**Consultation title:** PLANNING OPTIONS FOR DIGITAL SWITCHOVER

**Name of respondent:** THE DIGITAL TV GROUP

## Ofcom consultation on Planning Options for Digital Switchover Draft 5 - 15 March 2005

Figure 12a Impulse Signal Power for Failure (dBc) 64QAM rate 2/3

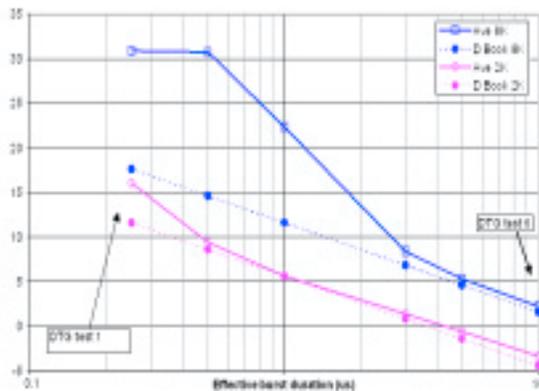
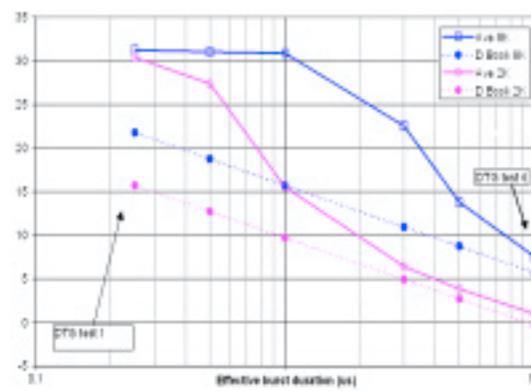
Results confirm that, at the longer impulse durations (DTG test 6), receivers tend towards the theoretical 6dB improvement of 8K over 2K. At shorter impulse durations, clipping in the receiver limits the disruptive power of impulses. Hence, in practice, 8K transmissions will have more than 6dB greater robustness than 2K transmissions.

The effect is particularly marked at 64QAM. There is a strong argument that 8K should be adopted wherever 64QAM is used. It should be noted that the major source of impulse noise causing reception defects reported in UK transmissions are generated within the home (eg thermostats and switches). Portable reception is likely to be prone to these defects.

Adoption of the 8k variant of DVB-T is supported by the DTG and the change should be implemented at the time of switchover, region by region, to minimise the number of and impact to current users of 2k only equipment. The DTG also urges Ofcom to ensure that clear communication, and adequate assistance and compensation is provided for these consumers.
